Subject: Data Gap Investigation Work Plan and Focused Conceptual Site Model
Haig's Delicacies, 25673 Nickel Place, Hayward, California
Fuel Leak Case No. RO0003243
Geotracker Global ID T10000010739

Subject: Data Gap Investigation Work Plan and Focused Conceptual Site Model
Haig's Delicacies, 25673 Nickel Place, Hayward, California
Fuel Leak Case No. RO0003243
Geotracker Global ID T10000010739

Subject: Conditional Work Plan Addendum Approval, Fuel Leak Case No. RO0003243 and GeoTracker Global ID T10000010739, Haig's Delicacies, 25673 Nickel Place, Hayward, CA 94545

FIGURE 2 – Site Map
25673 Nickel Place
Hayward, California

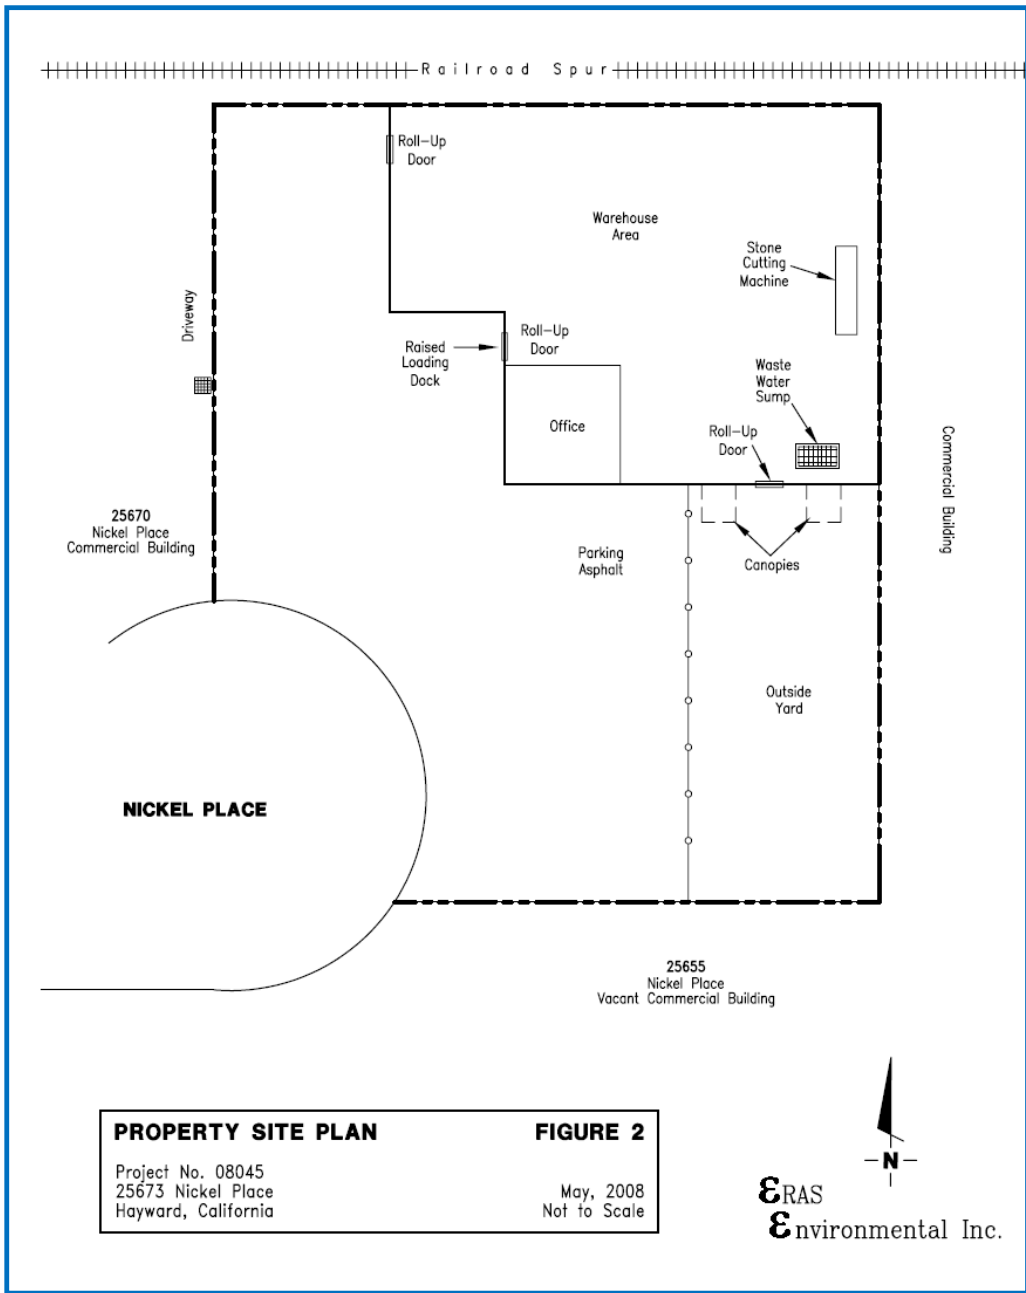
- Provide an extended site map with a bar scale using aerial photograph as a base with a bar scale to depict the site and surrounding area. *See Figure 1.*

FIGURE 3 – Site Map from 1998 ERAS Phase I ESA

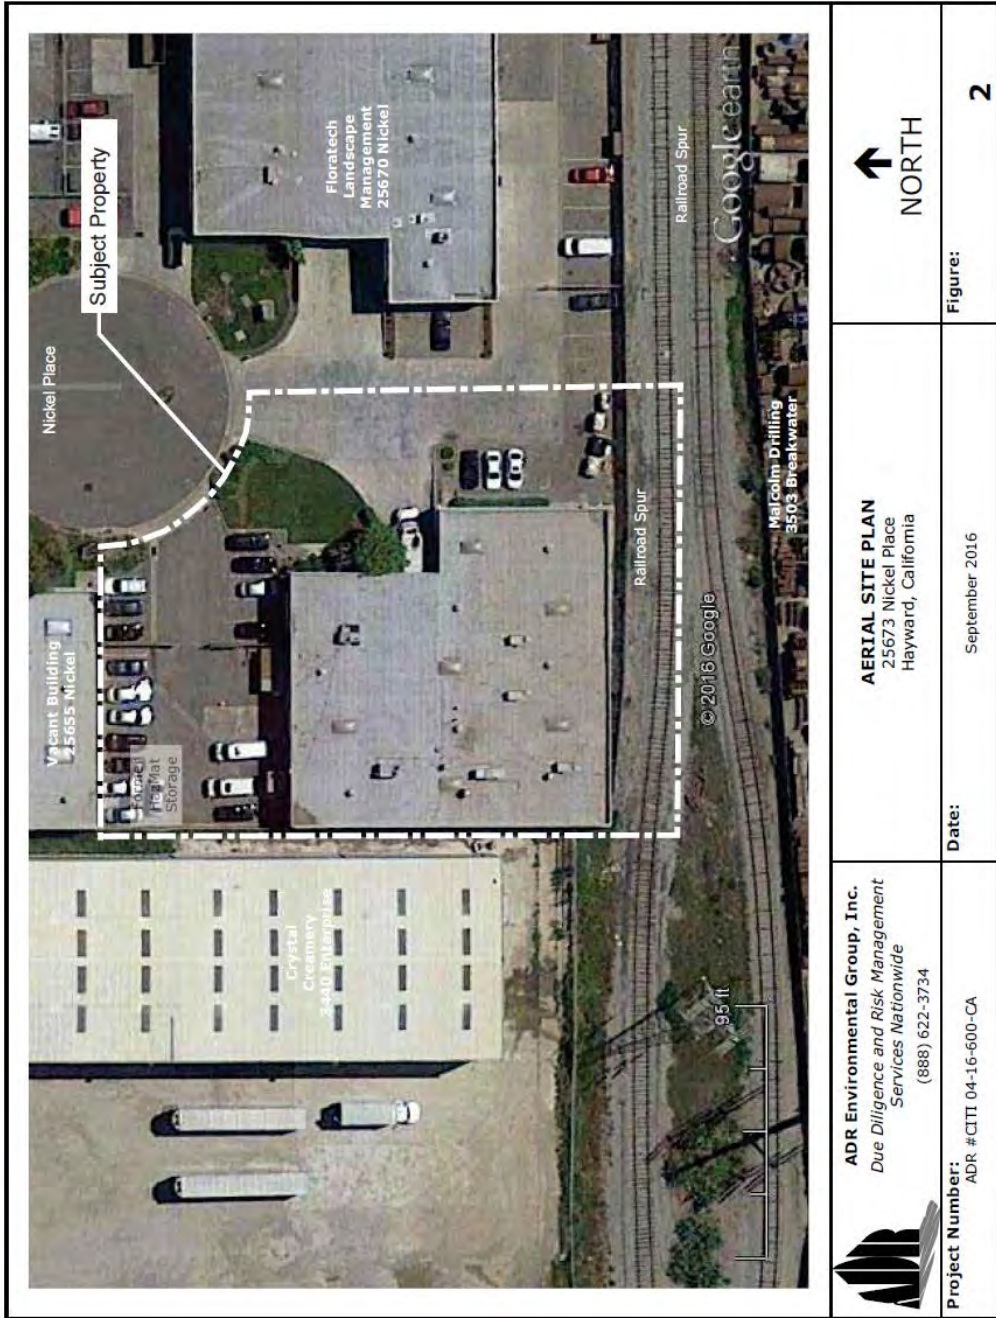
- The former waste water sump identified in the 2008 ERAS Phase I Report has not been evaluated as a potential source. *Based on the location shown on the 2008 ERAS map (attached as Figure 3), the former sump appears to be in what is now the refrigerated food preparation area. AWR will collect grab groundwater and soil vapor samples close to the former sump area without entering the actual food preparation area. Although this is not right at the former sump, it will provide additional data on the concentrations to determine if the former sump is a source.*

NOTE: FIGURE COPIED DIRECTLY FROM ERAS MAY 2008 REPORT.
NORTH ARROW ON ERAS FIGURE IS INCORRECT
NOT TO SCALE

FIGURE 5 – Site Sketch from 1993 HMMP copied from 2016 ADR Phase I ESA

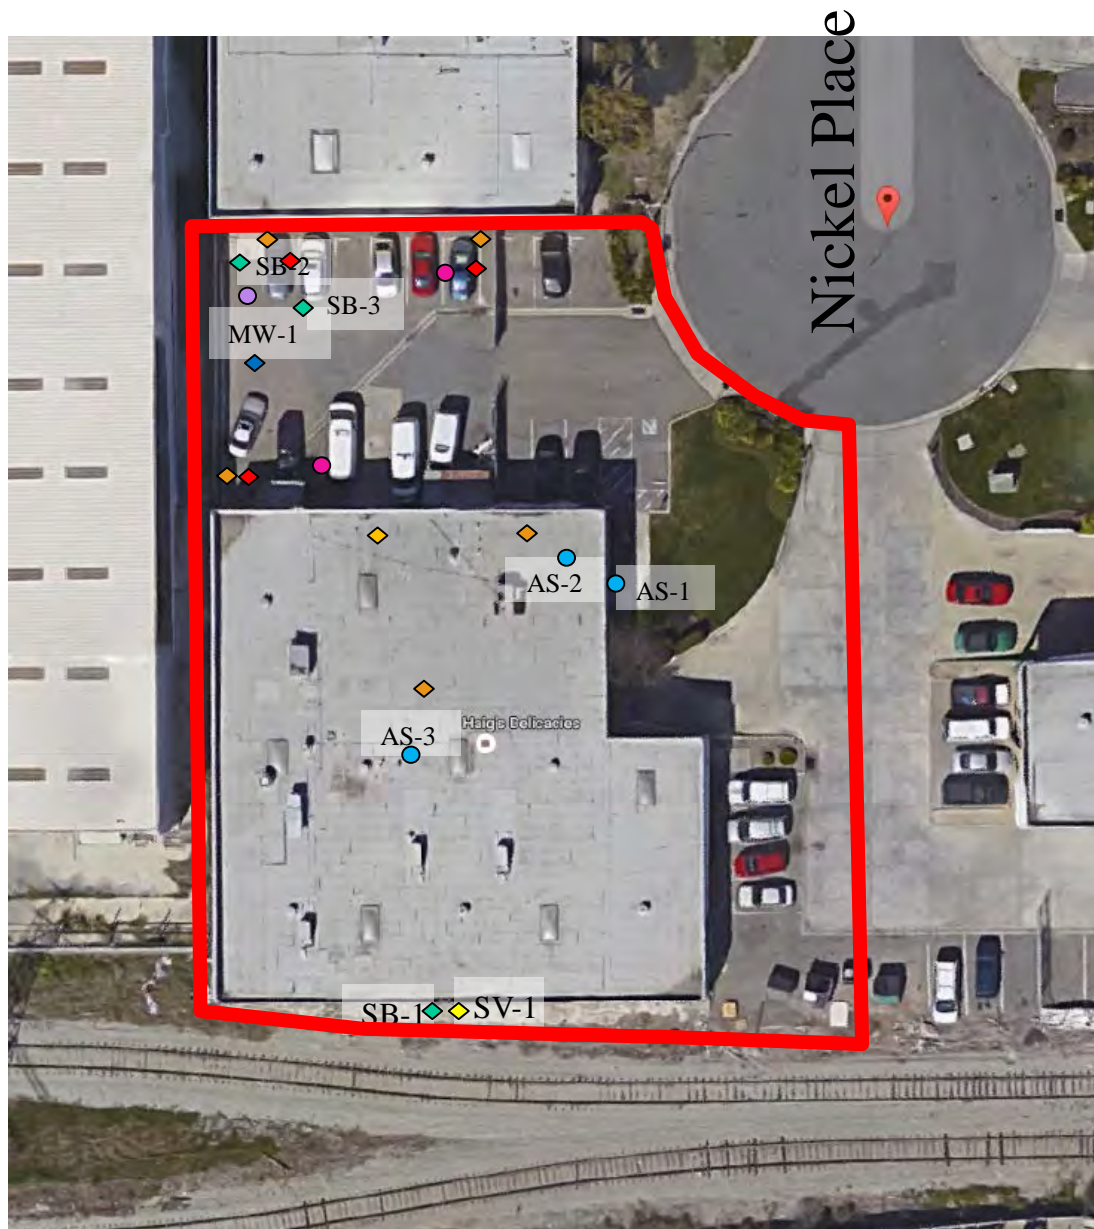
- Provide a detailed site plan showing chemical and waste storage areas for former site occupants. *The only figures we have seen that depict the former site layout are included as Figure 3 (2008 Site Map) and Figure 5 (a site sketch from a 1993 Hazardous Material Management Plan obtained from the Hayward Fire Department for the 2016 Phase I ESA). Both have limited detail and are not to scale, but to the best of our knowledge, these are the only figures publicly available. The current owner/occupant has only been involved with the site since 2007-2008 and their only knowledge of former site operations is what was in the Phase I ESA reports.*

NOTE: Figure copied directly from 2016 ADR Phase I ESA which in turn copied this from Hayward Fire Department records reviewed of a Hazardous Materials Management Plan (HMMP) prepared in 1993 by then current occupant, Orlimar Golf Company. This is the only figure included in the 2016 Phase I ESA in the information from the Hayward Fire Department. Based on the information provided elsewhere in the 1993 HMMP records, the chemicals used by Orlimar Golf Company were stored in metal cabinets inside in Area A and in the outside metal shed identified as B on the figure.

No scale is provided on sketch and no other figures are presented in previous reports showing former chemical storage areas.
